Video Products
Technical Bulletin 2001-105

Model: BVM-D24E1WE, BVM-D24E1WU

Date: June 18, 2001
Subject: BEAM SPOT

Figure 1

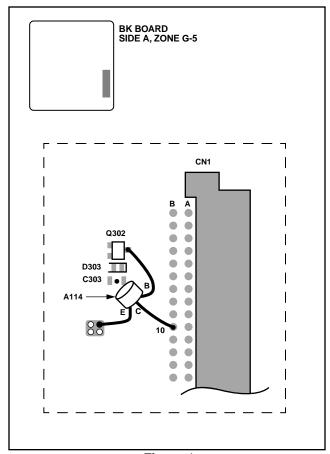
MODIFICATION PROCEDURE BK Board (Side A, Zone G-5) (See Figures 1 and 2.)

Solder the transistor A114 as follows:

Emitter: Digital 5V bus (near four thru-holes)
 Base: Analog 5V bus (Q302 collector)
 Collector: G2 control output (CN1 pin 10B)

NOTE: Make sure when soldering that the leads do not come in contact with other leads.
